SUBJECT: Submits addl info & rev to util 850610 request to operate low level radwaste incinerator. Requests approval by Apr 1886.

Subject: Oconee Nuclear Station
Docket Nos. 50-269, -270, -287

(Response to Questions A(2) and B(1-5) of
NRC Request for Additional Information)

Figure 1

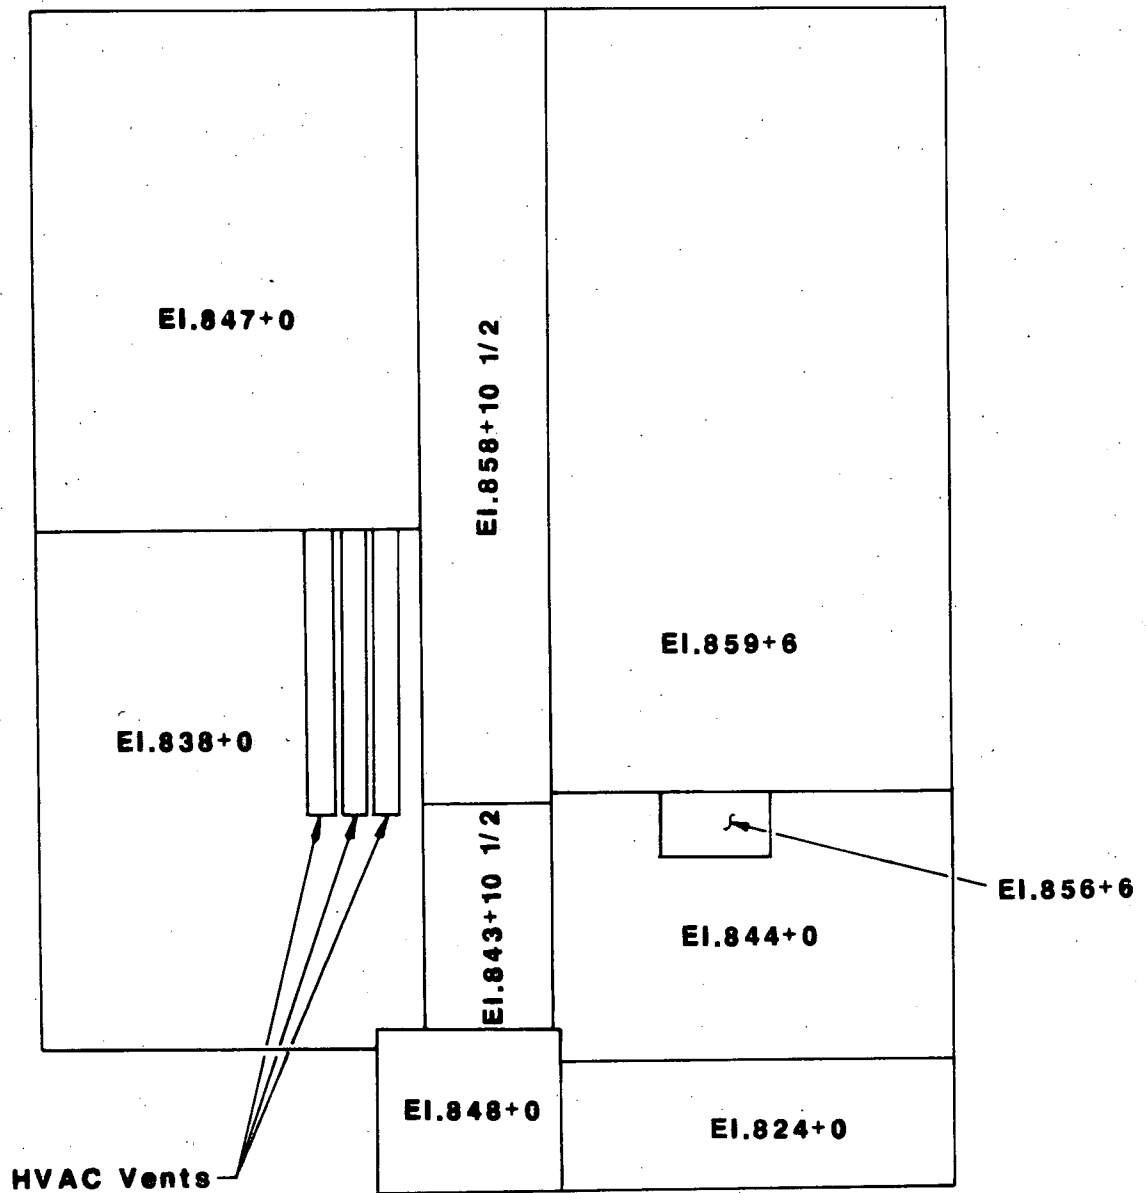
Atmospheric dispersion parameters such as relative concentration (X/Q) and relative deposition (D/Q) are dependent on location of releases, release characteristics (e.g., particle size, temperature, exit velocity, stack diameter, and duration) and influences of plant structures and terrain features. Provide a description of the release point(s), release characteristics, and other plant structures and/or terrain features which influence atmospheric transport and diffusion for both accidental releases and releases from normal operations of the incinerator.

Radiological effluents from the radwaste facility are exhausted horizontally through three 48" x 48" HVAC rooftop vents at an elevation of 843 feet MSL (47 feet AGL). (See Figure 1.) Exit speed is approximately 11 m/sec; exit temperature is assumed to be non-bouyant.

All accidental releases assume a two hour uniform release of gaseous or aerosol material through the HVAC vents and/or other building openings. The release point, therefore, is taken at ground level.

Normal operational releases assume a continuous uniform release of gaseous or aerosol material through the HVAC vents. The release point, then, is effectively at ground level due to the turbulent wake from higher structures in proximity to the radwaste facility building. For
